188 Beaumont Street Fast-track

Auckland Council Specialist Memo

Urban Design

2.0 Technical Specialist Memo – Urban Design

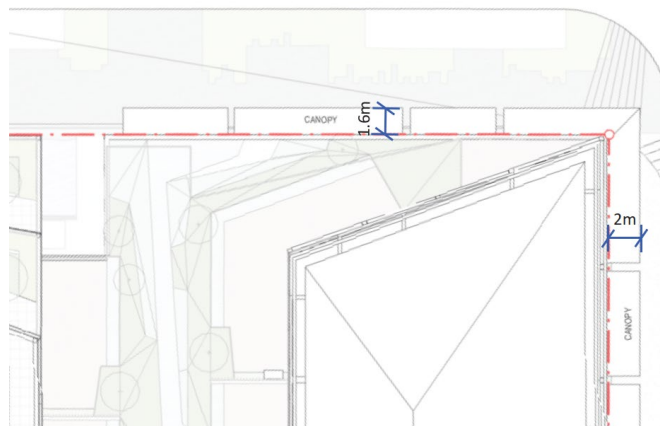
- 5.20 The Urban Design and Landscape Assessment highlights the shading effects on Silo Park and the residential development at 30 Madden Street. It identifies that the proposed buildings will primarily cast shading over Silo Park from late afternoon (approximately 4:45pm onwards) at the summer solstice, with over 50% of the central park area shaded by 5:45pm. Shading will also extend to the adjacent gantry structure and the grassed area surrounding the 'six-pack' former cement silos in the late evening. Given the high level of public and visitor use, including frequent summer evening events, it is questionable whether the proposed shading, particularly during periods of lower sun intensity, is acceptable.

- 5.21 At 30 Madden Street, the proposed buildings will result in shading to parts of the apartment units and townhouses along the northern and western façades during the winter solstice, for up to 1 hour 30 minutes in the afternoon (12:45pm–3:30pm). While these effects may be low in isolation, development in a dense built environment should account for cumulative shading from surrounding buildings, including the Orams boat shed, Marine Village, and any future multi-storey development at 37–55 Madden Street, which would likely compound the shading of these dwellings.

- 5.22 The application documents, however, have not addressed the shading effects on the adjacent eastern site (37-55 Madden Street), surrounding streets (Jellicoe Street, Beaumont Street and Madden Street) or Daldy Street Linear Park. In addition, the absence of comparative shading analysis limits the ability to understand the incremental effects of the proposed additional height and massing. It remains important to clearly distinguish and assess the extent of effects attributable to the proposed height and floor plate exceedances.

- 5.23 No assessment has been provided regarding the effects on daylight access to streets, public places and nearby sites (Assessment Criteria H8.8.2 (1)(a)). Given the pedestrian-oriented nature of Wynyard Quarter and the site's prominent waterfront location, a comprehensive and comparative daylight and shading analysis is warranted to fully quantify these effects.

- Provide a comprehensive shading, solar access, and daylight assessment to fully quantify cumulative environmental effects and determine whether the overall scale of the tower requires a reduction in height or floor plate area to mitigate adverse shading effects on key public spaces, streets, and adjoining properties.
